Rev A list of changes

PROJECT  
200 THE BROADWAY, YMCA  
LONDON, SW19 1RY

TITLE  
Level 02 Plan

DRAWING NAME  
PROJECT ORIGINATOR ZONE LEVEL TYPE ROLE NUMBER  
YMCA DLA 02 DR A 242

Proposed Second Floor Plan

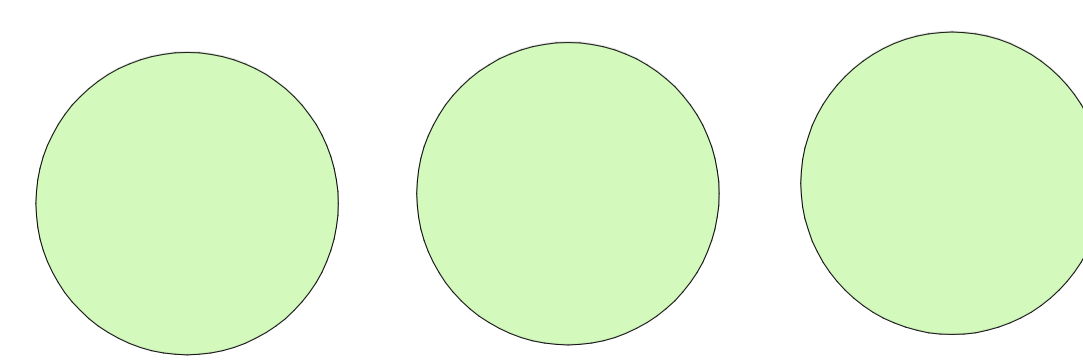
- Reduction in bedroom size in the 1b1p units.
- Addition of 750mm zone around beds in 1b2p central block units.
- Boundary treatment to ground floor duplexes on Trinity Road reduced from 1.5m height to 1.2m.
- Ground floor duplex gardens/bins store reconfiguration.
- Additional side door from servicing corridor to central commercial unit.
- Amendments to the enlarged cycle parking spaces to provide a secured and lockable store.
- Short stay cycle parking relocated from Trinity Road to central piazza.
- Provision of clear link from service yard to residential concierge lobby.
- Windows in YMCA amended to show perforated panels to avoid overlooking.
- Screen aligned with vertical mullions in central block façade facing The Broadway.
